13TH AND GLISAN

Pearl Building East
LU 16-153002 HRM AD

DAR ADVICE SUMMARY

SITE PLAN

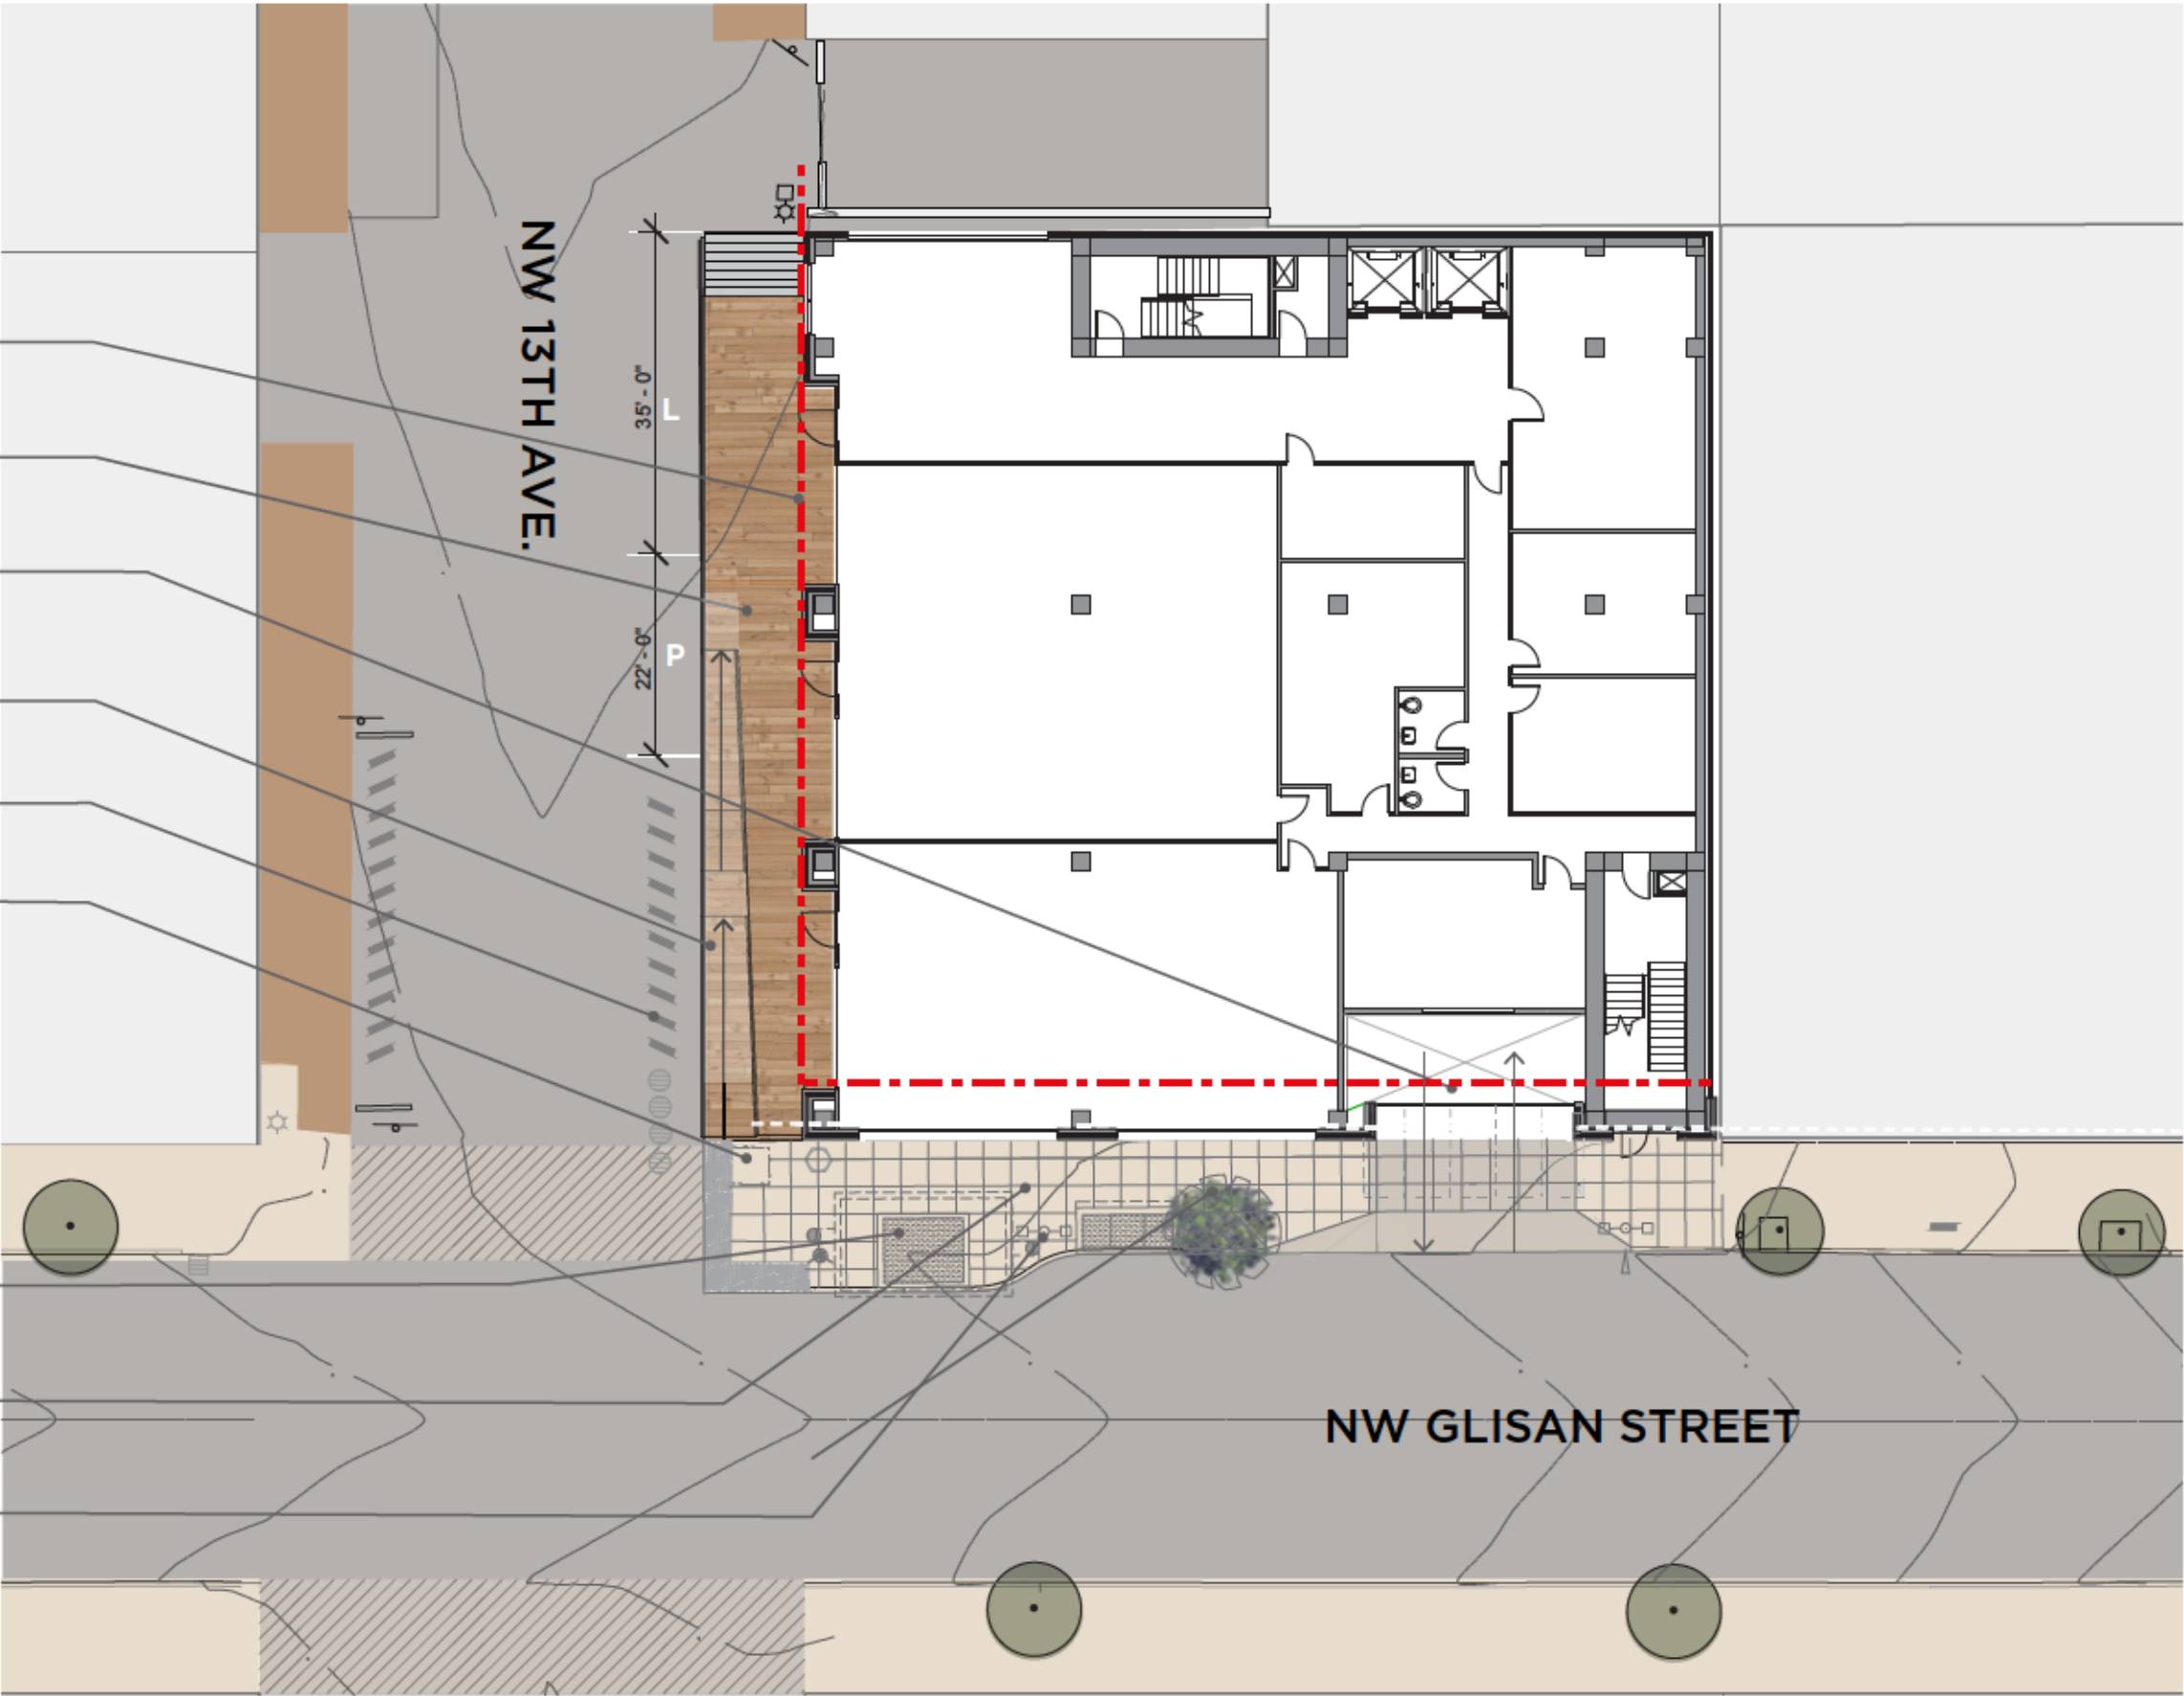
A. Consider decreasing the scale of the opening at the Glisan Street garage door.

B. Consider decreasing the scale of the concrete base at Glisan Street.

A. Project proposes a canopy over the garage entrance to visually break up the scale of the opening, especially at the pedestrian scale.

B. Project proposes boardform concrete at the base to provide scale and texture. Metal louvers with integrated benches, as seen on neighboring buildings, are also proposed to break scale of the base and enliven the human experience on Glisan Street.

BUILDING SCALE, MASSING AND MATERIALS

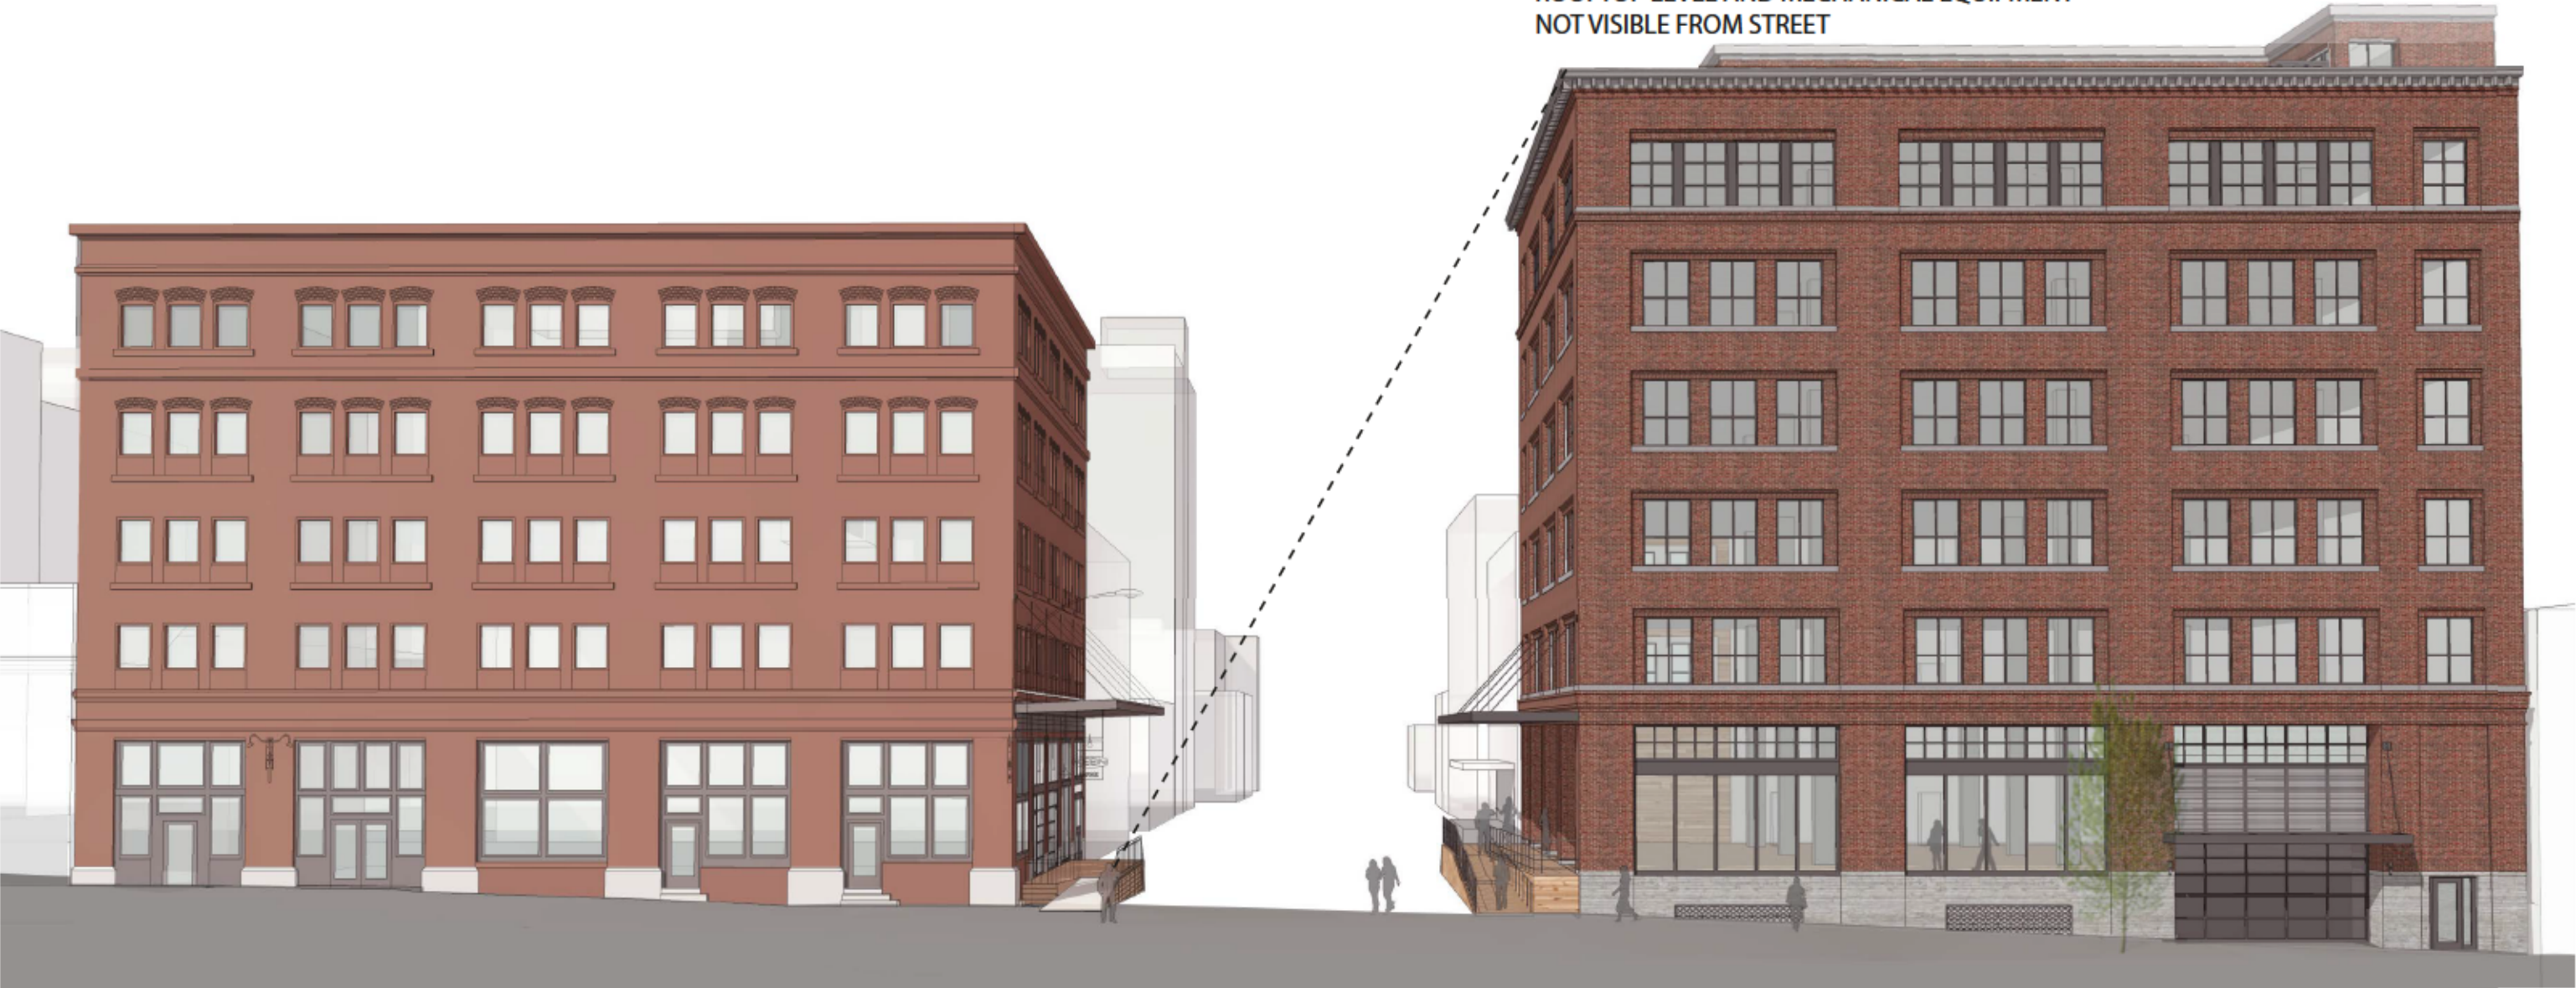
A. 6 stories with a set-back penthouse is approvable and appropriate.

B. Penthouse elements should not cause the building to appear as a 7-story building.

A. Consider simple, industrial style for penthouse materials that do not distract from main brick mass of the building.

B. Penthouse elements should not cause the building to appear as a 7-story building.

A. The project is proposed as 6 stories with a set-back penthouse.

B. Project proposes that penthouse elements are set back and disconnected from the planes of all major facades.

A. Proposed materials are light colored to blend into sky and not distract from the bulk of the building.

B. Project proposes that penthouse elements are set-back and disconnected from the planes of major facades. The parapet acts as a natural guardrail so no additional guardrail element is needed. The deep cornice reduces sightlines of the penthouse from the street.

ROOFTOP LEVEL AND MECHANICAL EQUIPMENT
NOT VISIBLE FROM STREET
